400 SW MARINE DRIVE (COMPLETE APPLICATION)  
DE415055 - CD-1 (Pending)

#### DEVELOPMENT PERMIT STAFF COMMITTEE MEMBERS

**DEVELOPMENT PERMIT STAFF COMMITTEE RECOMMENDATION: APPROVE**

Sheet  
**P-A-106**  
Title  
**OVERALL PLAN LEVEL 01 - MARINE**

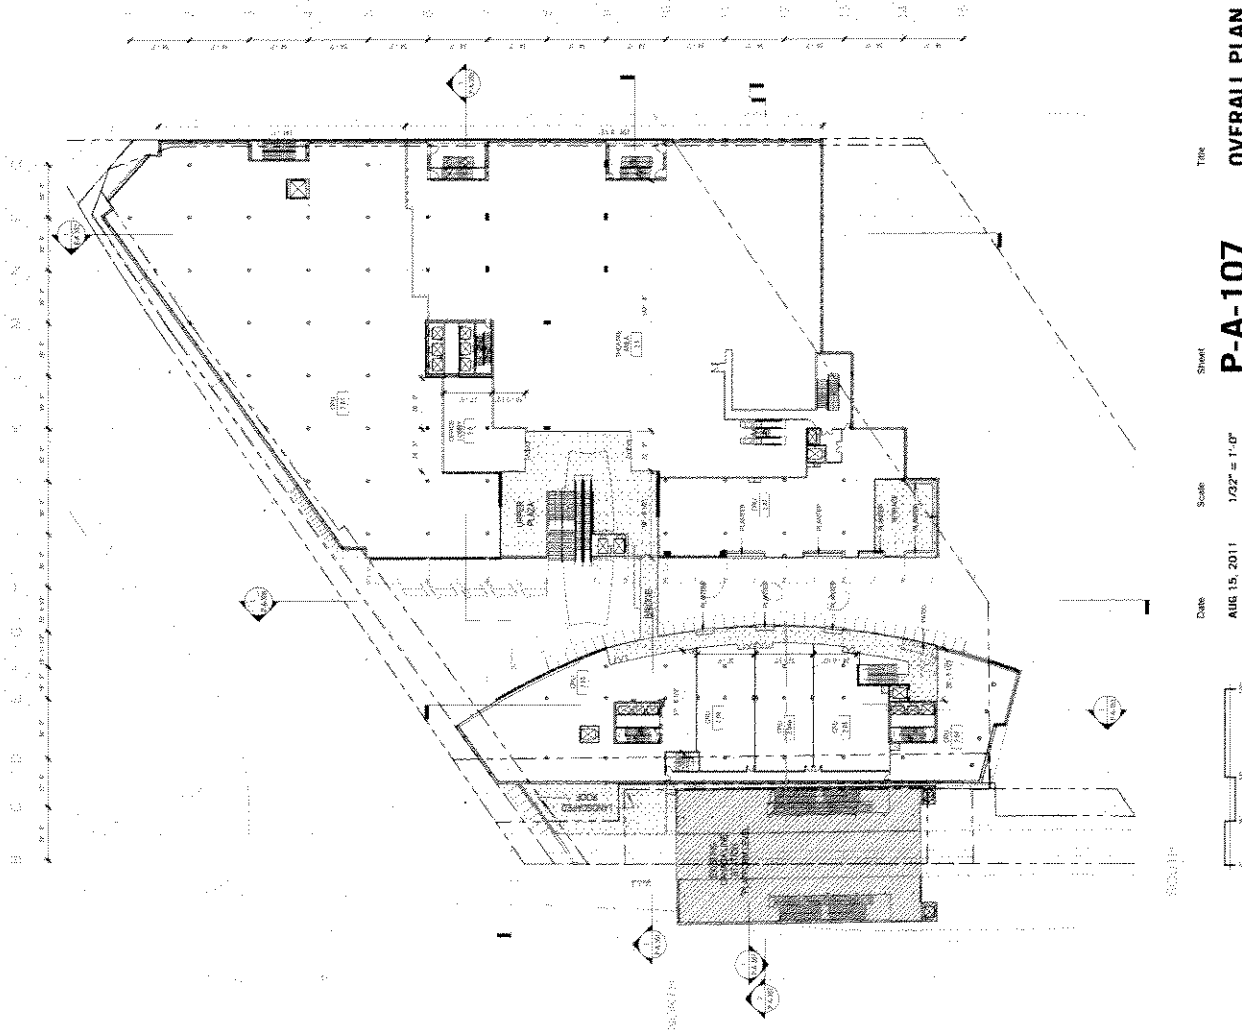
**Note to Applicant:** Confirmation from Development planner and agreement from Engineering Services as to the final SRW/building design and location at the North West corner of the site will be required (See P-A-106).
